# RESTORATION OF QUEEN SQUARE

## THE FINAL STAGES

## REPORT OF STAKEHOLDER WORKSHOP

**JULY 22 2004**

**Group 3.**

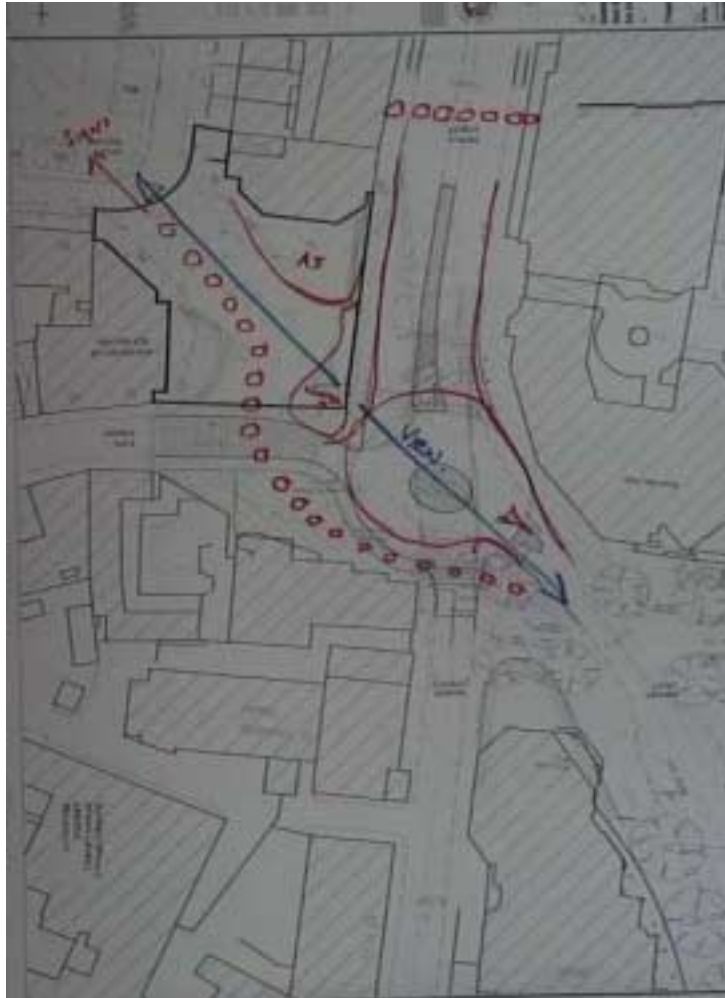
- Access orientated hard space
- With adjacent terrace café
- Visual conduit
- Ground level water feature & lighting, eyeline to King Street in evenings
- Brunel's statue at accessible level
- Pedestrian traffic flow round one side ie: raised base of King Street
- Same set for roundabout as Broad Quay Road
- Moving traffic lights back to stop cyclists on curb
- Prince Street aspect can be designed out. Barrier/extension of café terrace.

POSSIBLE PROBLEMS	THINGS YOU LIKE
Poss. Conflict between terrace in front of PO building & desire line to King Street	Raised pedestrian levels Statue
Roundabout must go	Routing of traffic up bottom King Street
Too much of a thoroughfare	
HLF will not be safe
